PERICA & ASSOCIATES
URBAN PLANNING P/L

Re: Submission – SSDA 88113706 – Nicholson Street Build to Rent

Figure 8 – Extract Chapter 4 Housing SEPP Assessment, Cox (pg. 6)

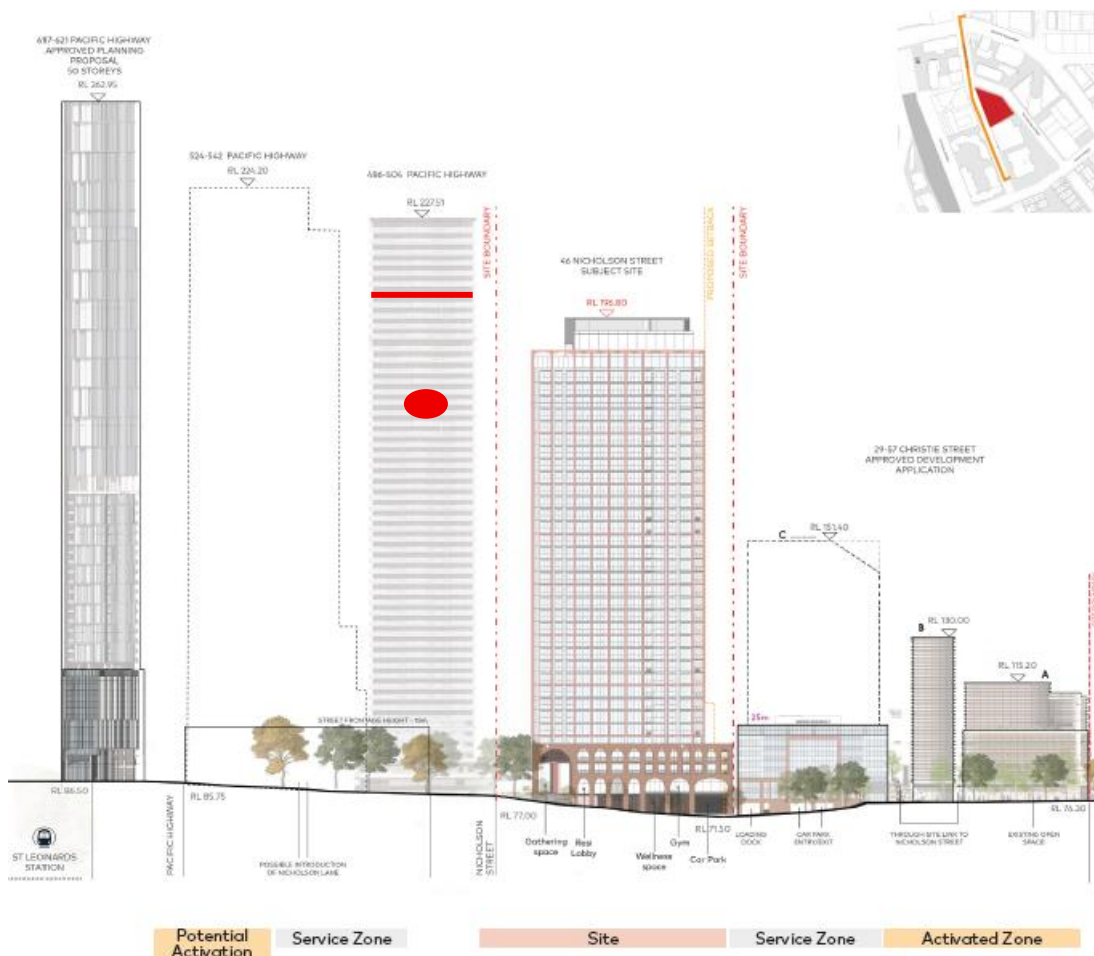
Unfortunately, the depiction of SLS across Nicholson Street in the 'Chapter 4 Housing Assessment' by Cox does not accurately portray my client's building/SLS and omits it altogether:

It may be this is meant to be the Landmark building and the labelled address of 486 Pacific Highway is wrong. But it does have the effect of omitting No. 486 Pacific Highway/SLS altogether, to create a visual effect of greater stepping down across Nicholson Street than actually occurs (the red line in the Figure above is the approximate height of SLS, 23m lower than the building illustrated).

The SLS building has a height to RL 204.46, just 7.5m (approximately) higher than the proposal. This is an important visual omission, given the TOD Guidelines which seek to step the form down at the subject site from the height of SLS, not essentially match it.

Figure 10 – View modelling relative to SLS, 486 Pacific Highway and levels of SLS

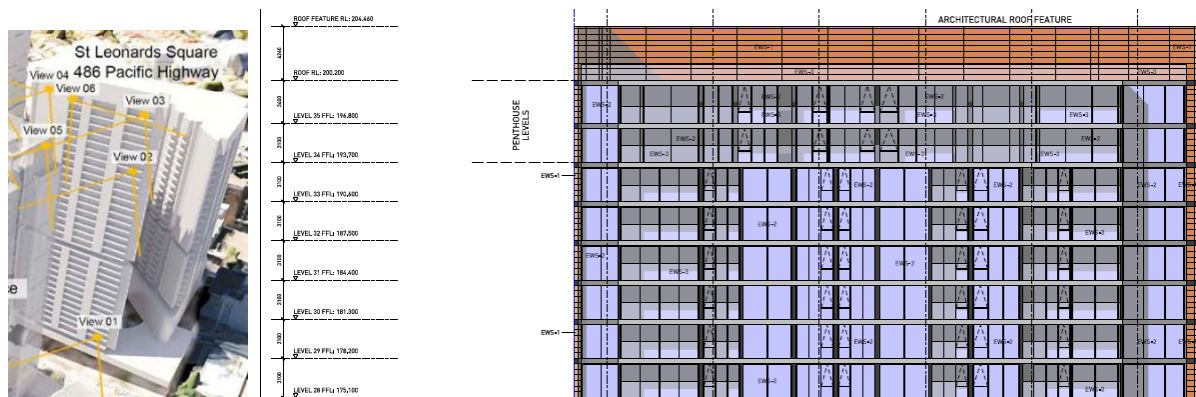
While view modelling has been done at level 34 of St Leonards Square, the assumed RL appears wrong.

Viewpoint 3, 4 and 6 all appear to be from Level 35 of St Leonards Square ('SLS', 486 Pacific Highway). However, the RL given in the methodological report by Virtual Ideas states this RL is 196.3.

The floor level given for views 3, 4 and 6 within my clients building is 196.3. However, the RLs I have from the elevation (supplied by my client) shows level 35 (top level) of SLS has an RL of 196.8, while the floor level of level 34 (one below the top level) is RL 193.7. So, the RL of 196.3 does not seem to align with an expected eyeline (floor + 1.5-1.6m).

Figure 12 – Upper Levels of SLS Building

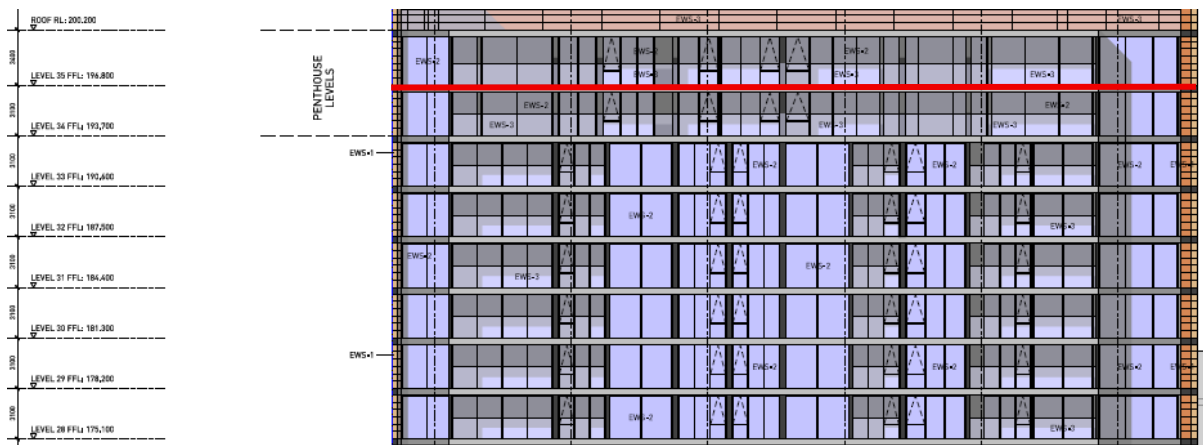
As such, the key levels and units impacted by the proposal are units between RL 175 and the new maximum proposed height of RL 196.8 (RL 197 in the PP). The height of the proposal is shown as red in an overlay of the SLS elevation below:

In turn, this directly impacts units from Level 28 (RL 175.1) and above in SLS, being 8 levels, noting the top level also has downward views over the site towards the Harbour waters.

Figure 13 – Typical Floor Plan - SLS Building

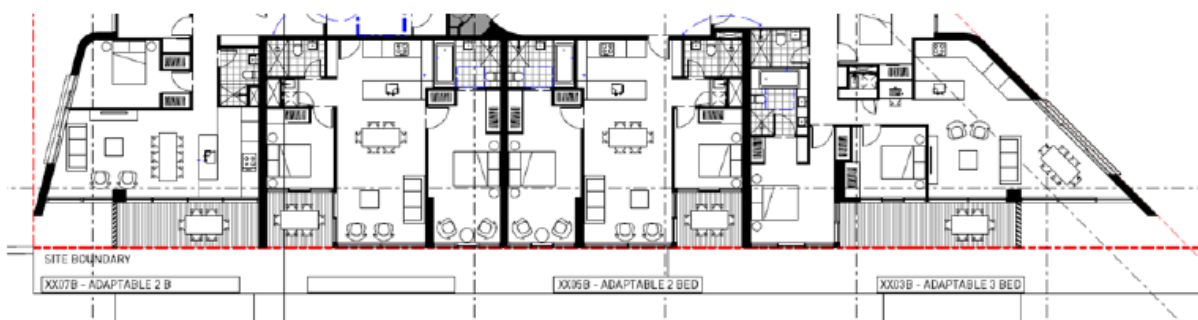
The floor plan of Jackson Building in SLS on levels up to level 34 is below, showing 4 units per level. Levels 34 and 35 have 2 units per floor facing Nicholson Street.

The impacts are greatest to the western (left) side of the building, although significantly adverse for all units, given views towards the Harbour as part of a wider view arc.

As mentioned, the proposal will directly and significantly affect views of 8 levels of SLS (28 units). To illustrate the view impacts (which will be similar for these top 8 levels), the following photos are from the living room (standing) and adjoining outdoor balcony (standing) at the western unit on level 34.
